E8363CH85-02

S E R V I C E N O T E

E8363CH85 PNA Microwave Network Analyzers

A new touchscreen display inverter shield is available to improve PNA noise floor performance.

Figure 3

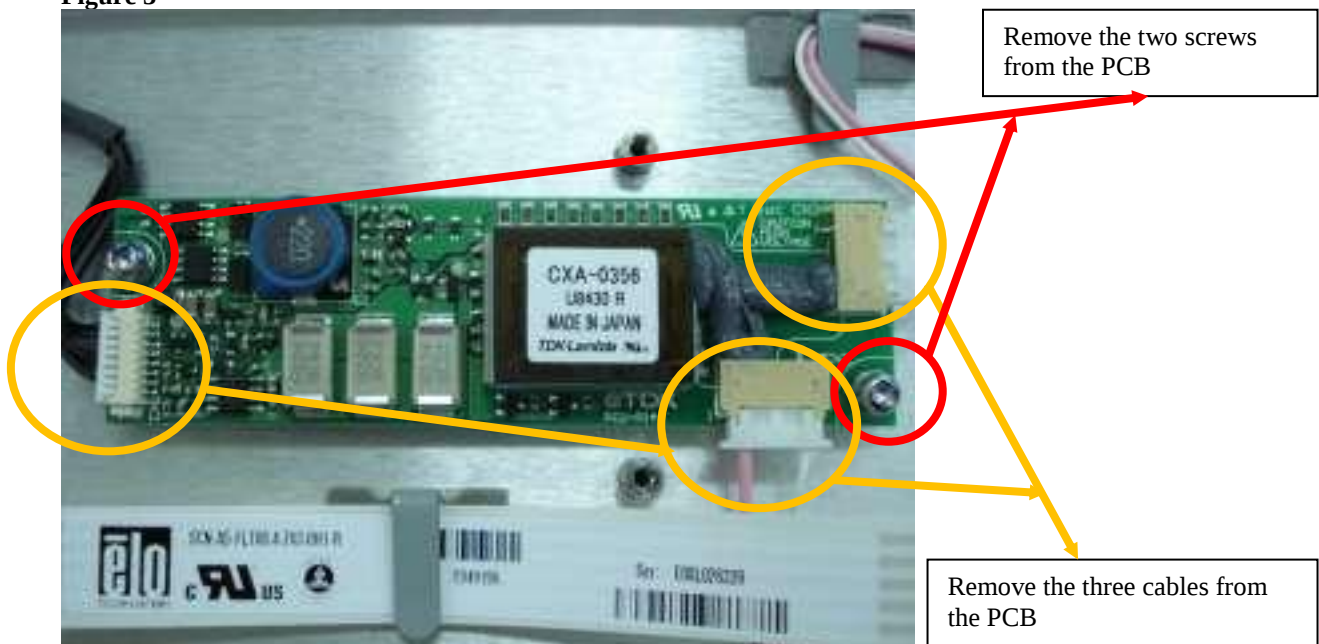
10. Remove the two screws from the PCB shown in Figure 3, using a T-10 wrench.
Disconnect the three cables connected to the PCB.
